Colorado Department of Health

Review and Comment

Technical Memorandum 1 - Revisions to Final Phase I
RFI/RI Workplan, December, 1991

FIGURE A

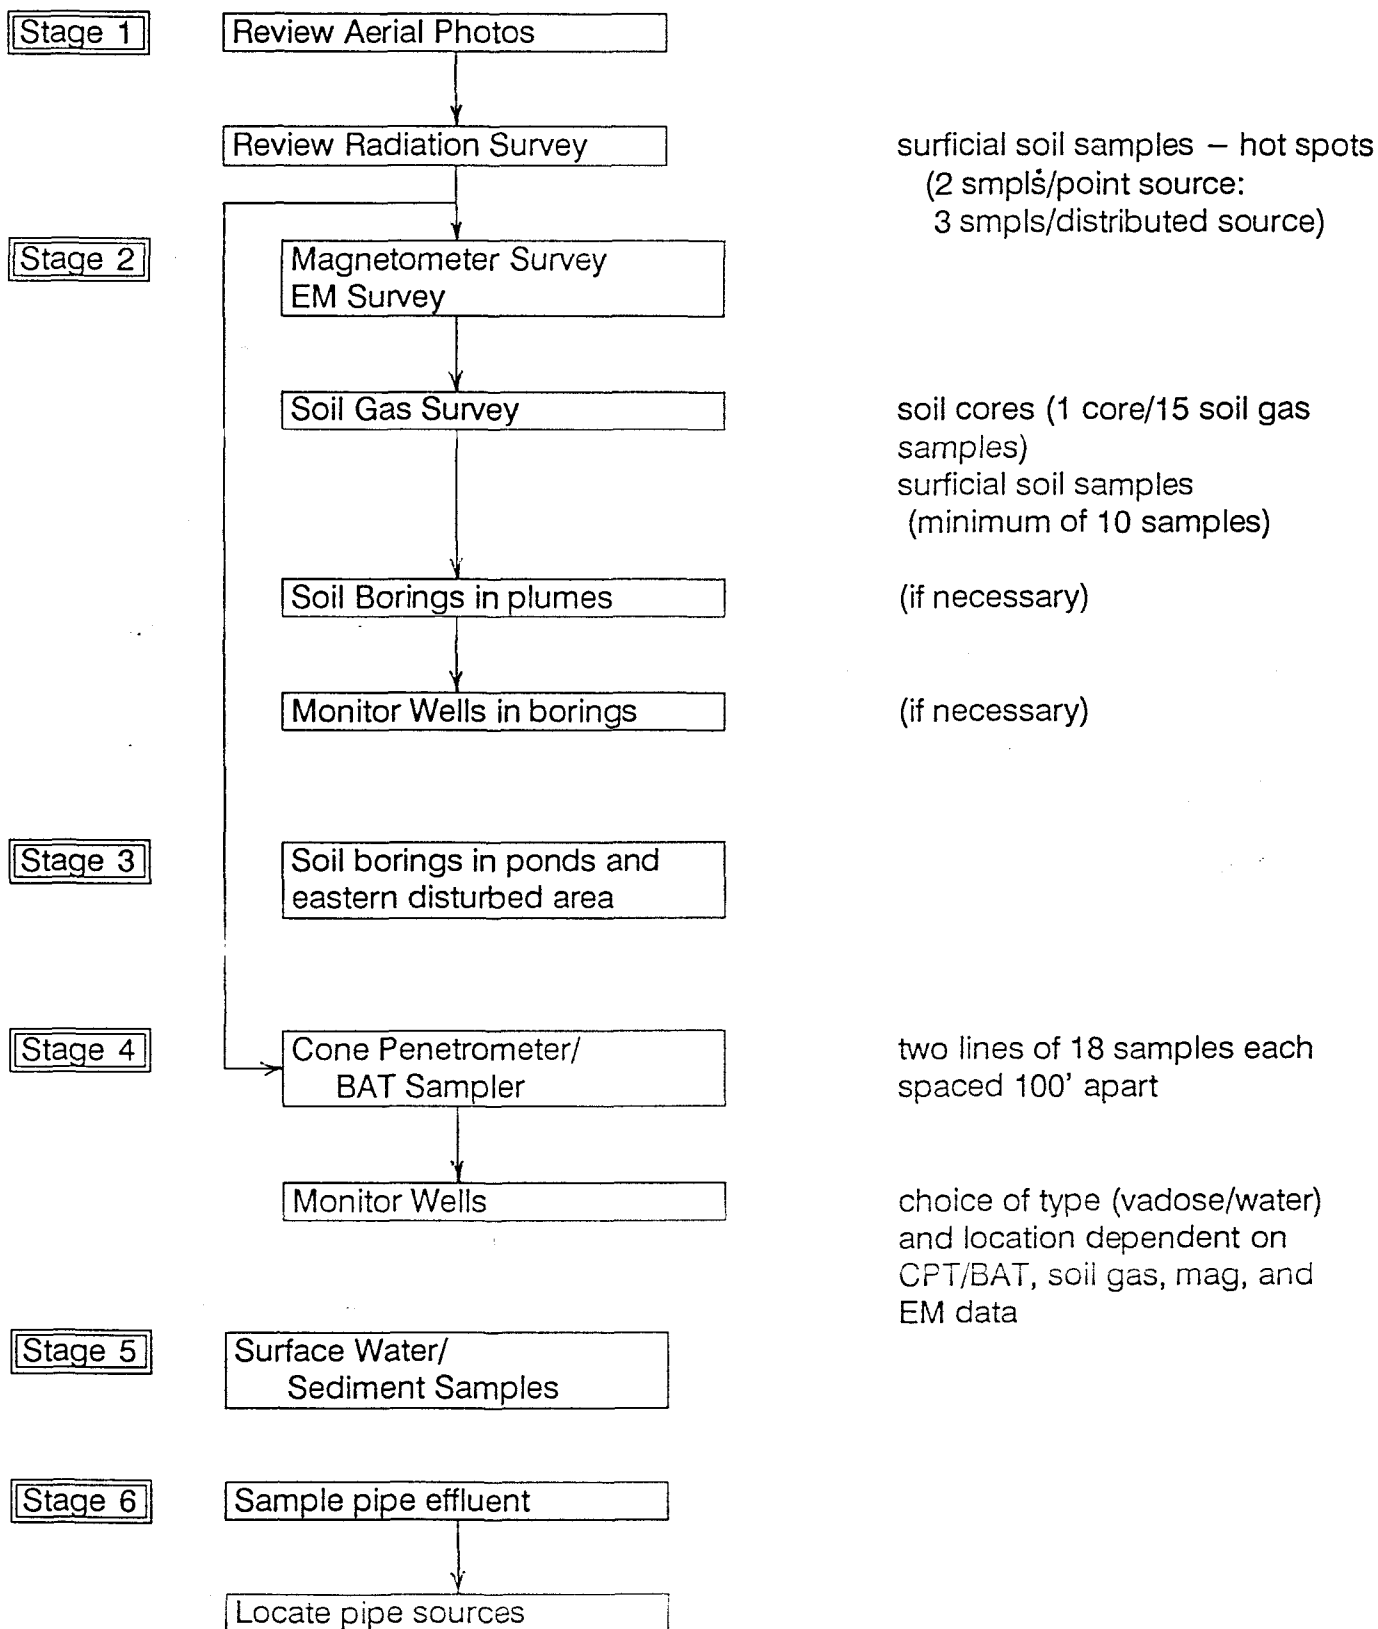
Section 2.0: Although substantial improvements have been made to this section, no conceptual model diagram of the Old Landfill was included in this section. We believe this is nothing more than an oversight because a satisfactory diagram was distributed at the November 11, 1991 meeting discussing this subject. Please include an official version of this diagram in this document. (A copy of the diagram we received is attached.)

FIGURE B

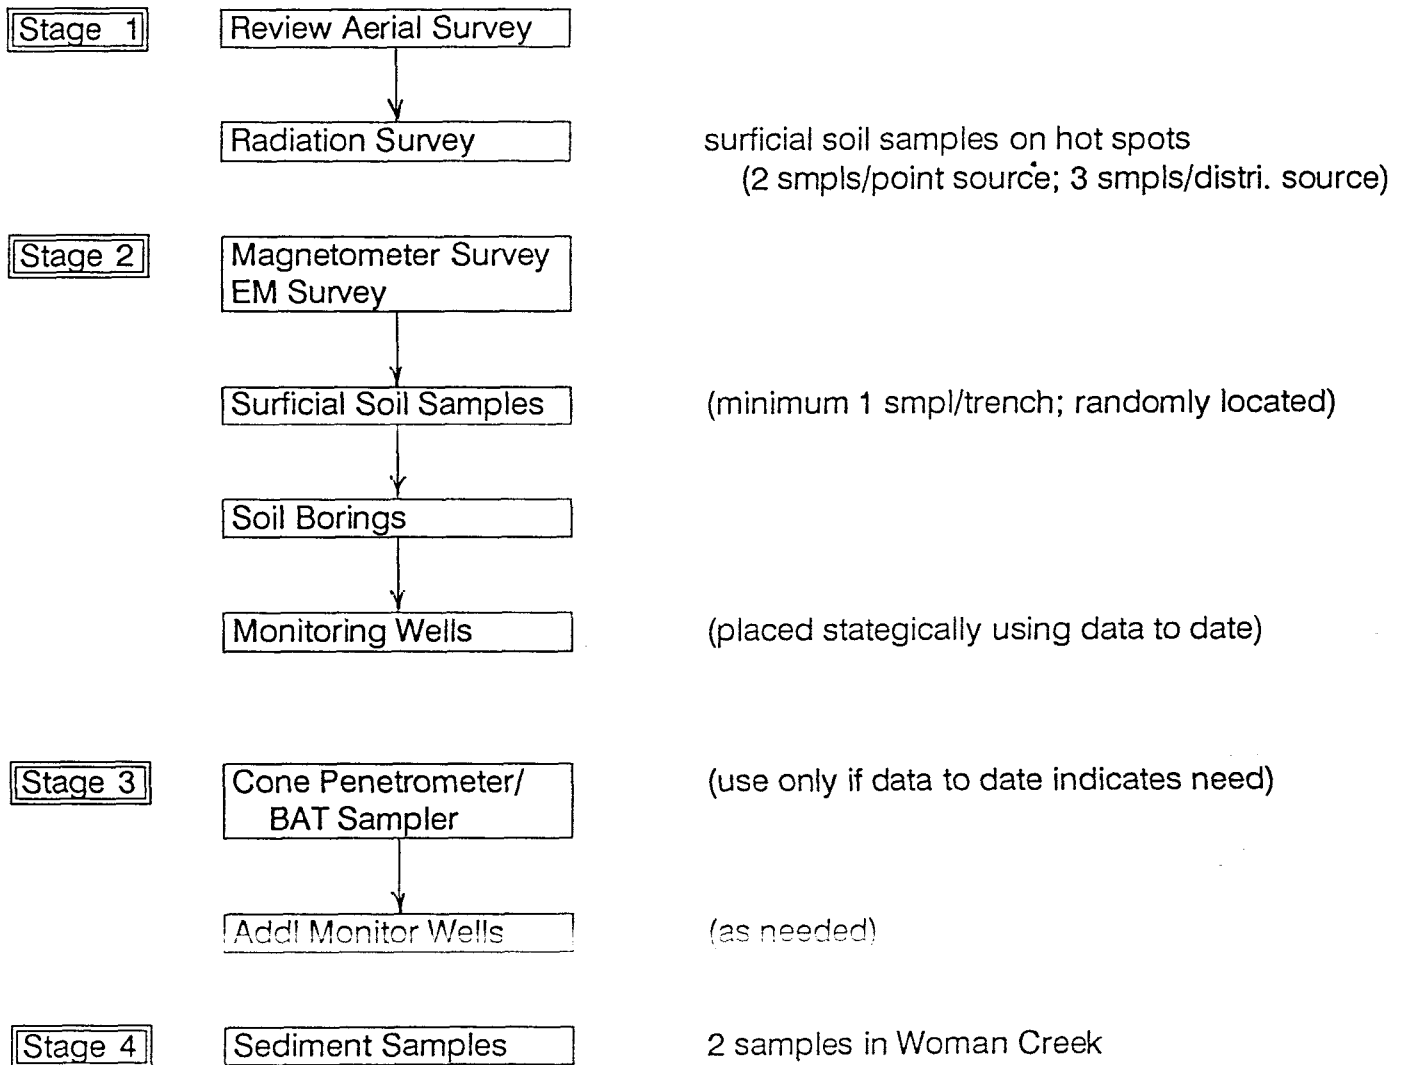
Section 7.2.2: This section should be re-formatted to present the FSP for the ash pits in chronological order, similar to what was presented for the Old Landfill previously in these comments. (Please see attached Figure B.)
